SECTION 4.55(1A) | APPLICATION TO AMEND DA-279/2019/A | 1 NORTH TERRACE, BANKSTOWN

This letter has been prepared by Urbis Pty Ltd on behalf of Vicinity Centres PM Pty Ltd (the Applicant) in support of a section 4.55(1A) application to modify DA-279/2019/A, dated 30 November 2020 which applies to the approved development at 1 North Terrace, Bankstown.

The modification is for amendments to the approved managed parking scheme and alterations to the operation of the existing car park within Bankstown Central Shopping Centre.

Figure 2 Proposed modifications – Location 5

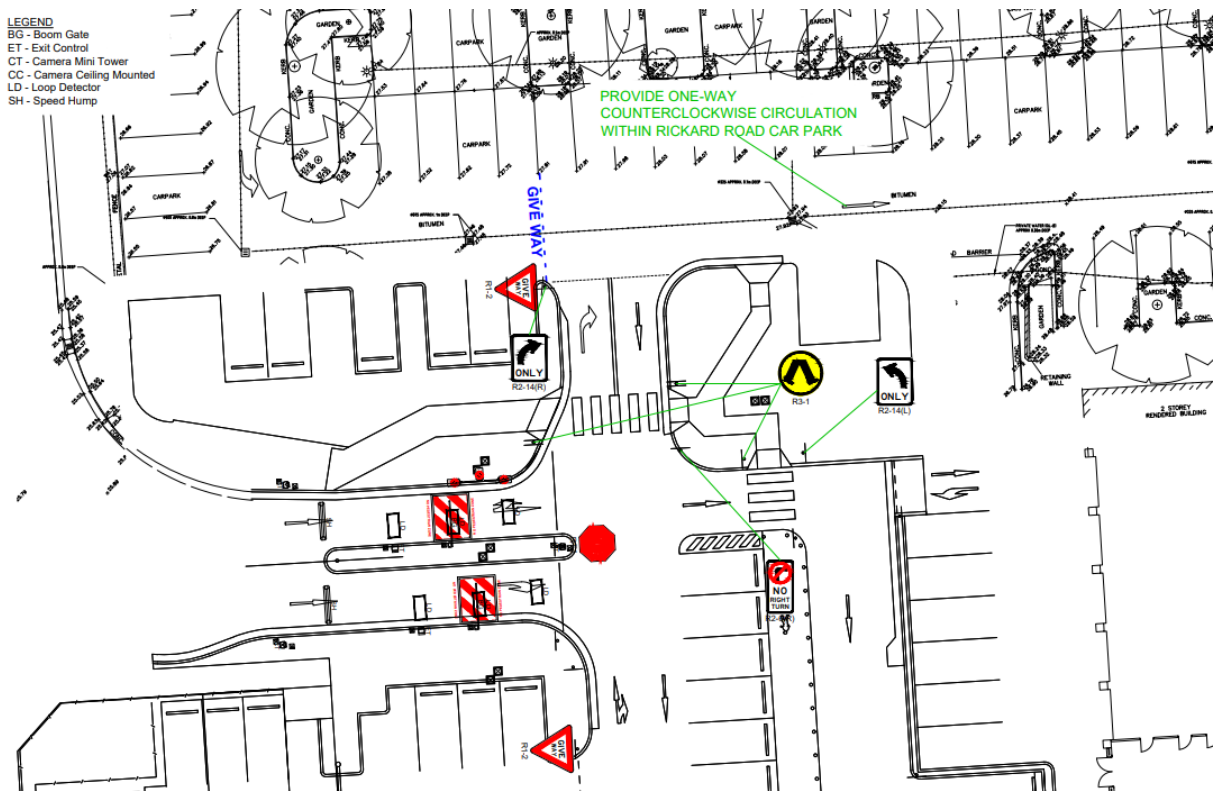
New Location 5

- The existing entry lane from Jacob Street has been reconfigured in association with DA-26/2021, to provide two entry lanes, including one left and through traffic lane and one right turn only traffic lane;
- The two entry lanes will include an LPR system and boom gate controls. Speed humps will be located on the entry lanes to control travel speeds;
- The boom gates will be reverse logic (boom gates maintained in an opened position, unless activated by loop detectors to prevent vehicles exiting the car park from the proposed entry controls);
- Raised kerbs/medians and line marking have been provided to channelise traffic entering the car park at this location;
- Reconfigure car park circulation within the existing Rickard Road at grade car park, to provide counter-clockwise traffic circulation;

- All traffic entering the Rickard Road at-grade car park from the new Jacob Street car park will be required to turn right onto the internal car park circulation aisle;
- Install Give Way signage and line marking within the Rickard Road at grade car park, to ensure priority to traffic entering from the new
- Jacob Street car park connection, in order to minimise traffic queues and traffic delays at this location;
- Maintain the existing pedestrian access and marked pedestrian facilities within the new Jacob Street at-grade car park.

Figure 3 Proposed modifications – Location 5A.

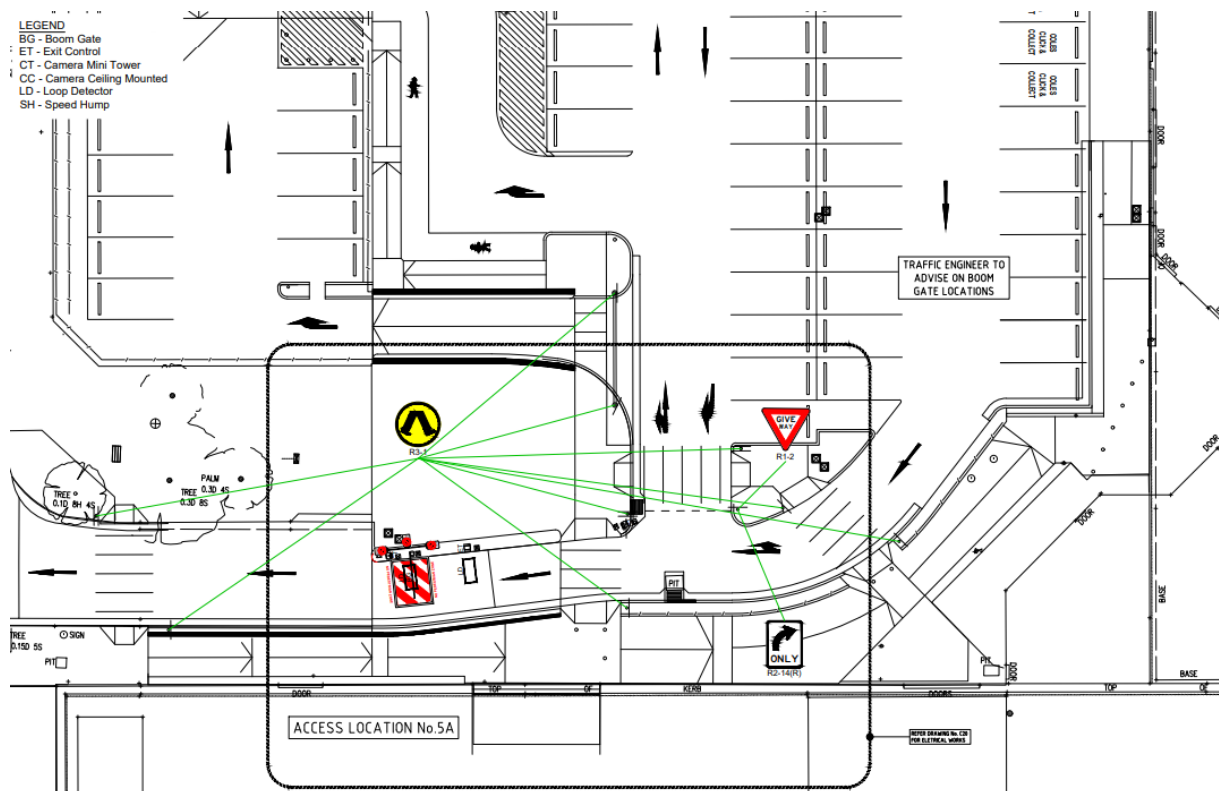
Location 5A

- The existing egress lane from the Jacob Street car park has been reconfigured in association with DA-26/2021, to provide a single egress lane onto Jacob Street at The Mall;
- The egress lane will include an LPR system and boom gate controls. Exit payment controls will also be available for customer who choose to pay on exit from the car park;
- Raised kerbs/medians and line marking have been provided to channelise traffic exiting the car park at this location;

- Provide for the recirculation of vehicles within the new Jacob Street at-grade car park, past the proposed egress lane;
- Maintain the existing pedestrian access and marked pedestrian facilities within the new Jacob Street at-grade car park.

Figure 4 Proposed modifications – Location 6

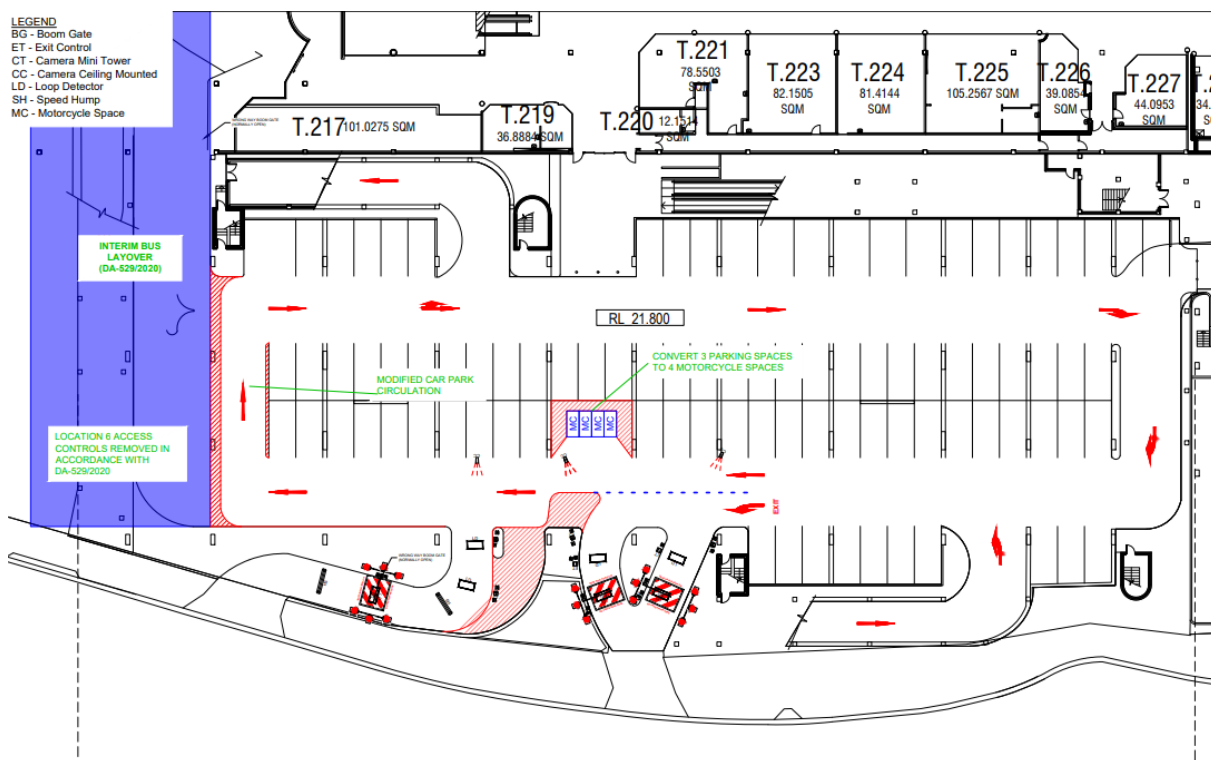
Location 6

- The existing entry and exit lanes at the western end of the North Terrace multi-deck car park and the B2 exit ramp have been removed in association with DA-529/2020, to provide for the new interim bus layover within the site;
- Car parking arrangements and internal circulation within the North Terrace multi-deck car park have been reconfigured to cater for the changed traffic arrangements and traffic recirculation;
- Modified structure, raised kerbs/medians and line marking have been provided to channelise traffic through the car park at this location;
- Maintain the existing pedestrian access and marked pedestrian facilities within the new interim bus layover and modified North Terrace car park.
